January 2, 2007

Red Rock Rural Community Association, LLC (RRRCA) &
Sierra Club
c/o Brian P. Myers
PMB 217
2370 West Highway 89A Suite #11
Sedona, Arizona 86336

RE: Bella Terra and Section 404 of the Clean Water Act

FIGURE # 1 IRRIGATION DITCH AND PROPOSED CULVERT OUTLET

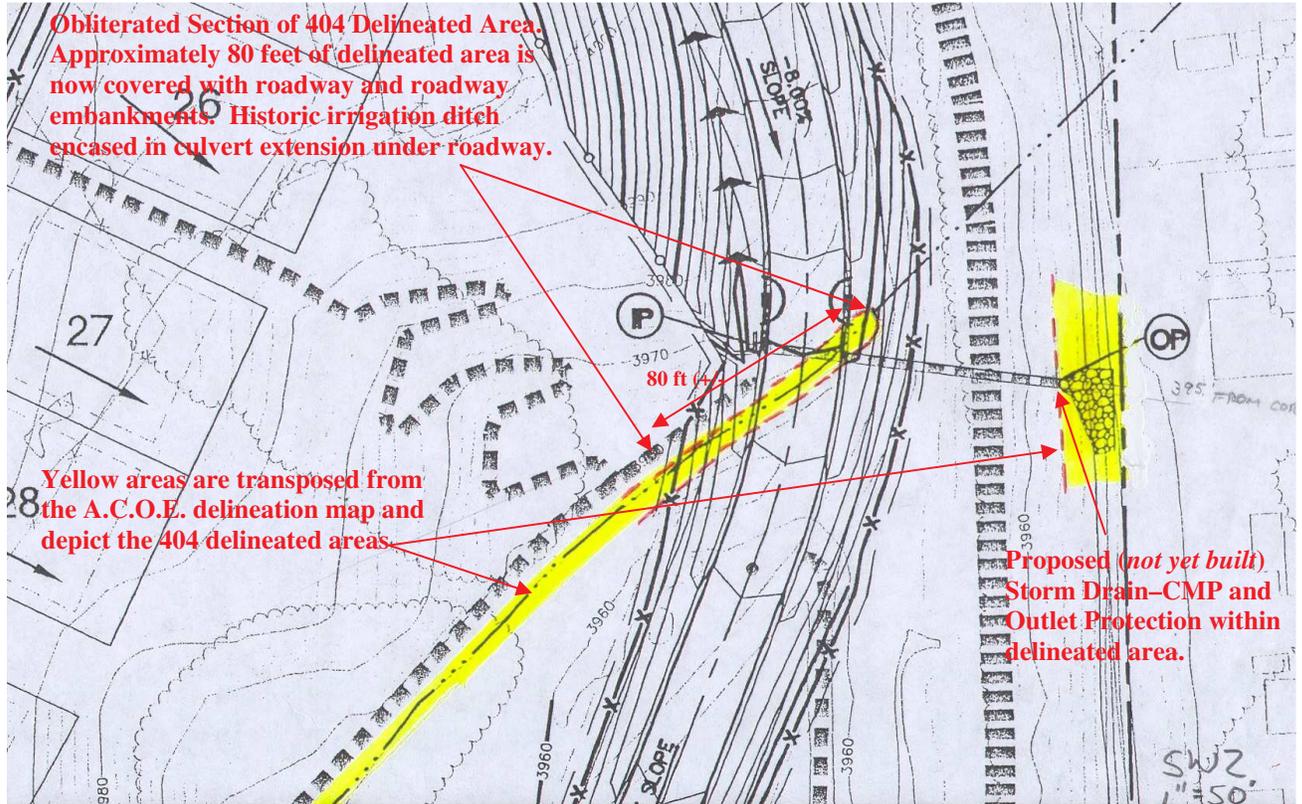
1. Historic Drainage Ditch.

A Nationwide Permit– 02 (NW-02) for Structures in Artificial Canals is required for culvert extension into the Historic Irrigation Ditch. The A.C.O.E. delineation included all open channel portions of the historic irrigation ditch which crosses the Bella Terra site. The Jurisdictional Delineation Map and original aerial photograph upon which the map was based shows the irrigation ditch extending, as an open channel, to within 110 feet (measured along the ditch trajectory) of the Bella Terra property line (PL) which follows Carrol Canyon on the east side of the project. Project plans and field measurements show that 80 feet +/- portion of the irrigation ditch which was previously an open canal is now buried and enclosed in a corrugated metal pipe (cmp). Figure 1, Irrigation Ditch and Proposed Culvert Outlet show these described features. The outlet of the underground portion of the irrigation ditch is now approximately 190 feet (measured along the ditch trajectory) of the Bella Terra Property line (The outlet was previously 110 feet from the P.L.). No permits for this construction within the jurisdictional delineation were applied for despite the developer’s initial nomination and ACOE’s concurrence and ultimate establishment of the jurisdictional standing of the irrigation ditch. This construction eliminated approximately 80 feet of the open ditch and the surrounding vegetation. No plans which addressed the impacts of the construction on water quality during the construction process have been located or identified. Reportedly during the construction of the additional culvert lengths approximately 40 feet of the original buried culvert was excavated, replaced and reburied along the historic irrigation ditch.

Field inspections, as well as comparison of the delineation map and subdivision maps, show that about 80 ft of a historic irrigation ditch **within the delineation area** has already been encased in a corrugated metal pipe (CMP). The yellow areas within this figure have been transposed to scale and reflect the limits of the 404 delineation areas as shown on the A.C.O.E. delineation map. (The blue portions of this figure are from the subdivision plans for Bella Terra by Shepard and Westnitzer. The)

The subdivision plans show a storm drainage structure starting at point P (see figure above) and extending to OP (see figure above). This structure has not yet been built. The outlet and outlet protection are, however, within the delineated area of Carrol Canyon and will require a 404 permit.

FIGURE # 2 CONSTRUCTED CULVERT & OUTLET

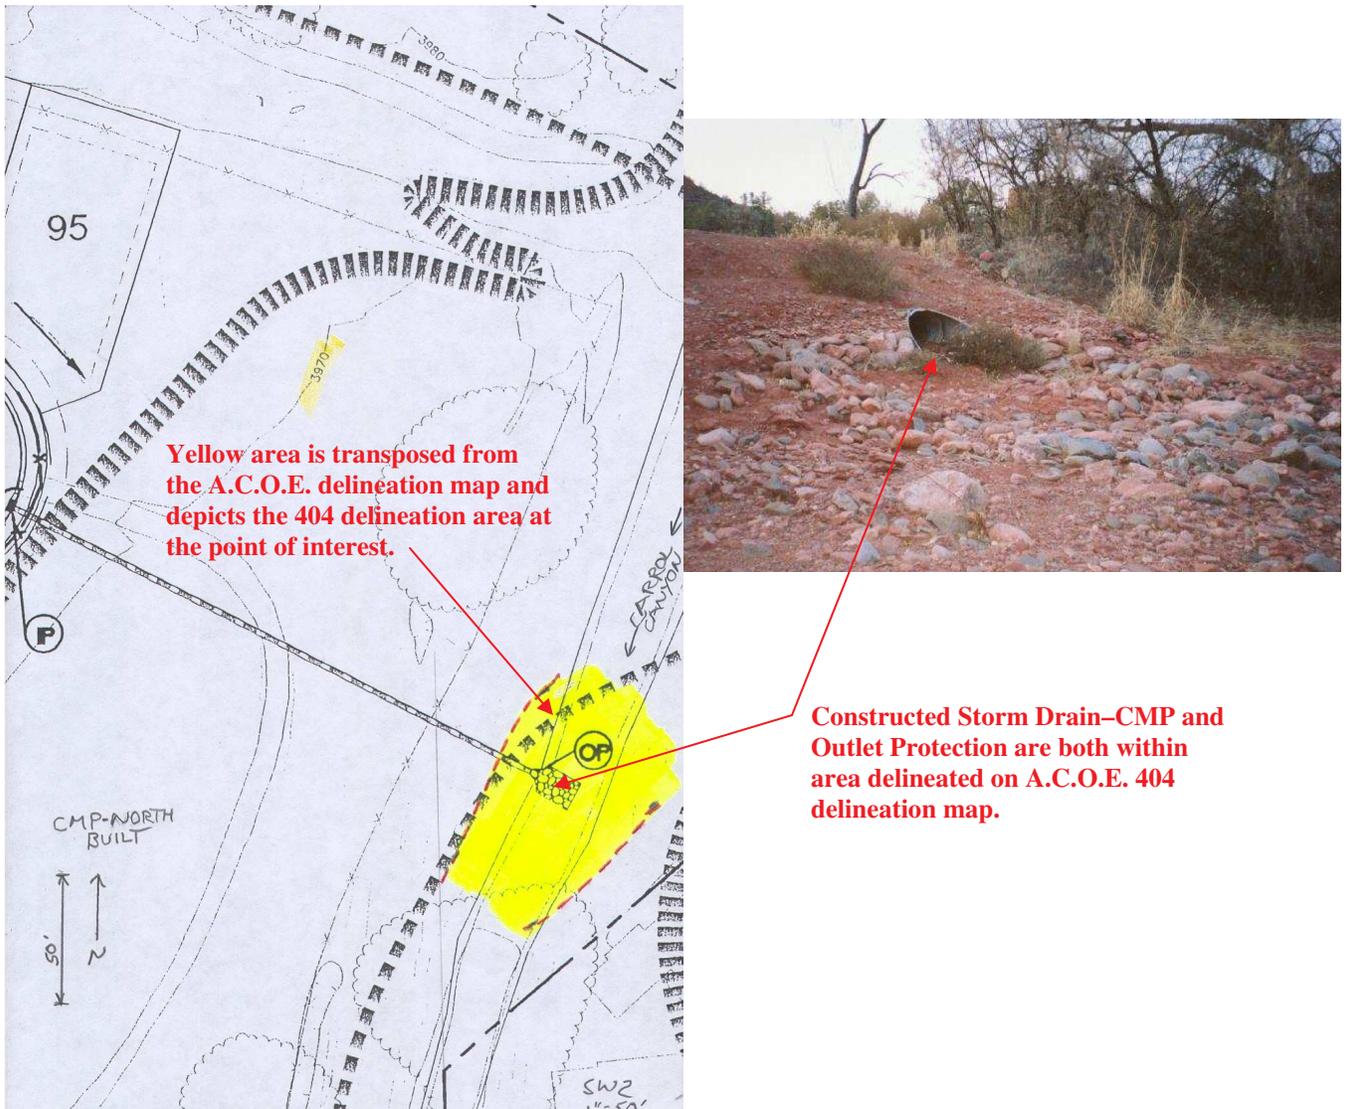
2. Constructed Drainage Structure.

A Nationwide Permit– 43 (NW-43) for Storm water Management Facilities is required for storm water facilities which impact on designated areas. Completed construction at Bella Terra, which follows the S&W subdivision plans, has resulted in a storm water drainage structure and outlet protection well within a designated area. This culvert exit is located near the upstream end of the segment of Carrol Canyon which borders the project site east of Lot 95 as shown in Figure 2 which includes a photograph of the newly constructed culvert exit. The jurisdictional delineation map includes a 30 feet wide delineated area along Carrol Canyon and explicitly shows the boundary of the jurisdictional area with highlighting. The delineated area encompasses the area disturbed by the construction of the culvert exit and associated erosion protection area. In addition, no storm water management plans which address the impacts of the construction itself on water quality during the construction process have been located or identified. This drainage structure has a significant amount of sediment in it already which likely entered from its upstream unprotected inlet which drains a highly erode-able low lying area proposed for development as a paved cul-de-sac in the project plans. It is likely that this drainage structure has already contributed silts and sediment to Carrol Canyon and Oak Creek during recent storms.

Field inspection, show an already constructed storm drain culvert which corresponds to a storm drain shown on the subdivision maps. The outlet and outlet protection of the storm drain is within the yellow highlighted delineated area (transposed from the A.C.O.E. 404 delineation map) The yellow areas within this figure have been transposed to scale and reflect the limits of the 404 delineation areas as shown on the A.C.O.E. delineation map.

Constructed Storm Drain–CMP and Outlet Protection are both within area delineated on A.C.O.E. 404 delineation map.

FIGURE # 3 PROPOSED CULVERT & OUTLET WITHIN DELINEATED AREA

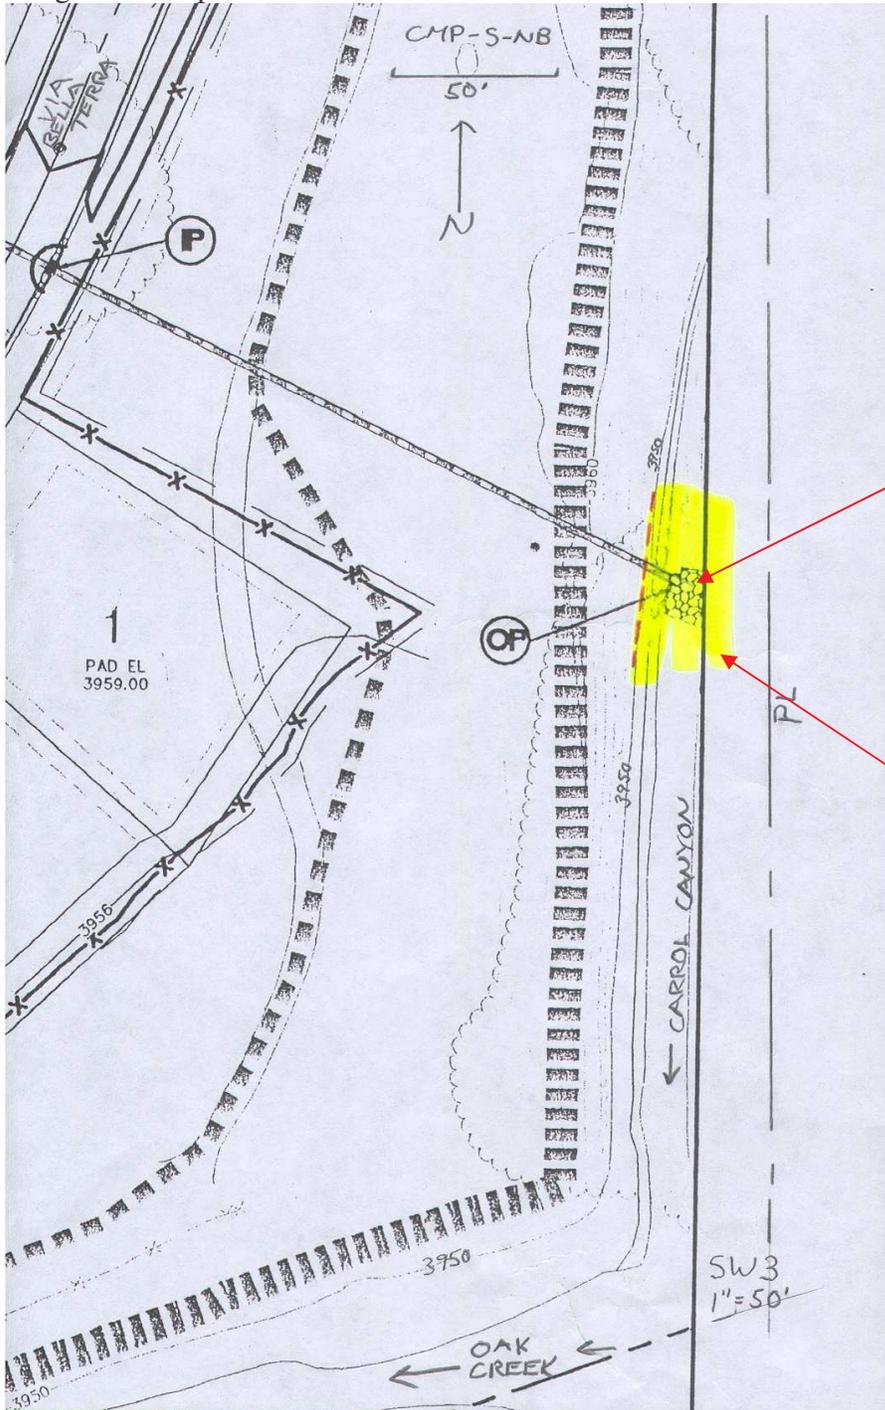
3. Planned Stormwater Features.

A Nationwide Permit– 43 (NW-43) for Stormwater Management Facilities is required for two additional storm drainage structures which are included in the plans for Bella Terra although they have not yet been built. The subdivision plans show a total of 3 cmp drainage structures which outlet or drain into Carrol Canyon along its western banks. One of these cmp pipes and its outlet structure has already been constructed in the delineated area of Carrol Canyon's banks as discussed above. The remaining two of the designed cmp storm drains also terminate within the delineated areas. Figure 1, Irrigation Ditch and Proposed Culvert Outlet, and Figure 3, Proposed Culvert and Outlet within Delineated Area, show these drainage structures as they are presented in the subdivision plans. Both of these drainage structures should be covered in a Section 404 permit application.

The subdivision plans show another proposed storm drain culvert to be located east of Lot 1 near the lower end of Carrol Canyon on the south east portion of the project site. The outlet and outlet protection of this proposed storm drain is within the yellow highlighted delineated area. The yellow areas within this figure have been transposed to scale and reflect the limits of the 404 delineation areas as shown on the A.C.O.E. designation map.

Proposed Storm Drain–CMP and Outlet Protection are both within area delineated on A.C.O.E. 404 delineation map.

FIGURE # 4 PHANTOM STORM DRAIN & OUTLET

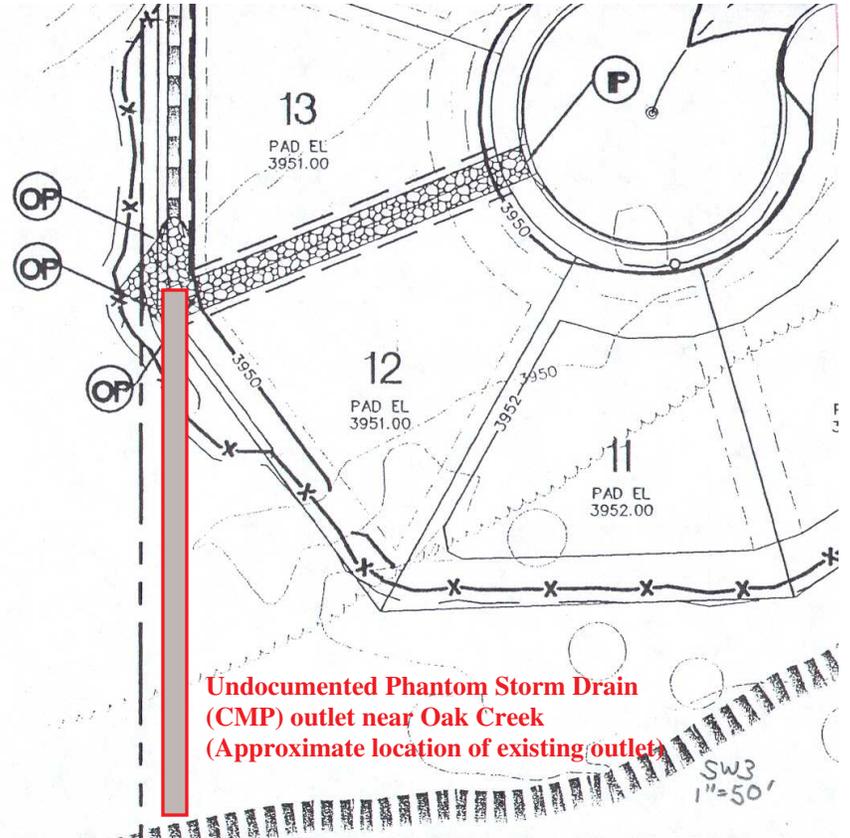
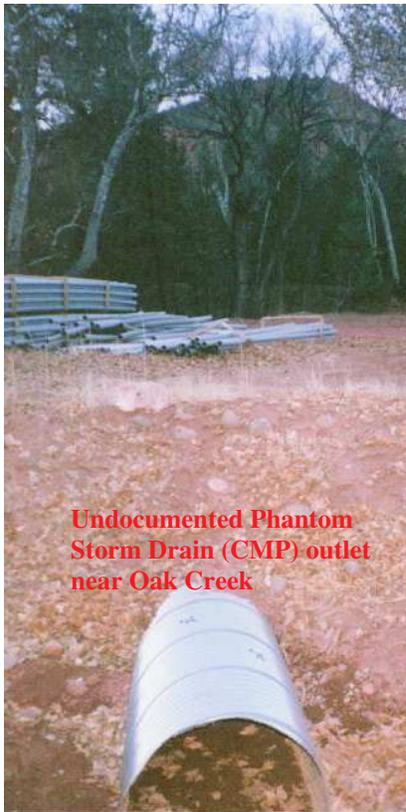
4. Phantom Storm Drain.

Visits to the Bella Terra site show an additional large diameter drainage pipe that is not documented in the S&W plans. Figure 4 Phantom Storm Drain shows the approximate culvert location on the subdivision plans and includes a picture of the structure. This undocumented drainage structure crosses a low lying area which appears to be below the high water mark of Oak Creek in the area. While not complete at this time, it is apparently intended to drain to Oak Creek by traversing the delineated area along Oak Creek. The terminus of this drainage structure has not been accurately related to the subdivision map or the delineation map at this time. This drainage structure is also already silting up as can be seen in the picture.

Field inspection shows that an additional storm drain built with corrugated metal pipe (CMP), has been constructed down to near the edge of Oak Creek. This CMP does not show on the subdivision plans at all. The outlet of this phantom CMP appears to discharge close to the delineated area of Oak Creek but without a careful survey the exact relationship of the CMP's outlet and the delineation boundary can not be accurately determined. This CMP as well as the delineation boundary should be included in the Storm Water plans as part of the Subdivision Plans available for review.
